Title & Document Type: HP 339A Operating and Service Manual

Manual Part Number: 00339-90001

MODEL 339A

DISTORTION MEASUREMENT SET

Figure 4

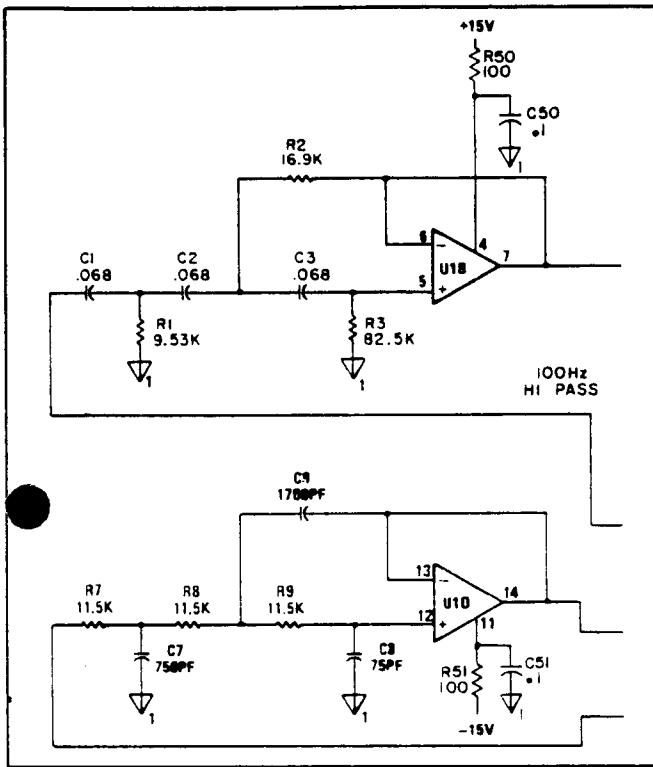
Page 8-19/8-20, Figure 8-16. Add R50, R51, C50, and C51 to the schematic as shown in Figure 4.

This change is to decouple power supplies on A2U1 to reduce the affect of internal oscillation on the 80kHz filter response. The values of C114, C115 and C116 are changed to compensate for the stray capacitance in the new 00339-26513 printed circuit board. (See change no. 13 for information on C114).
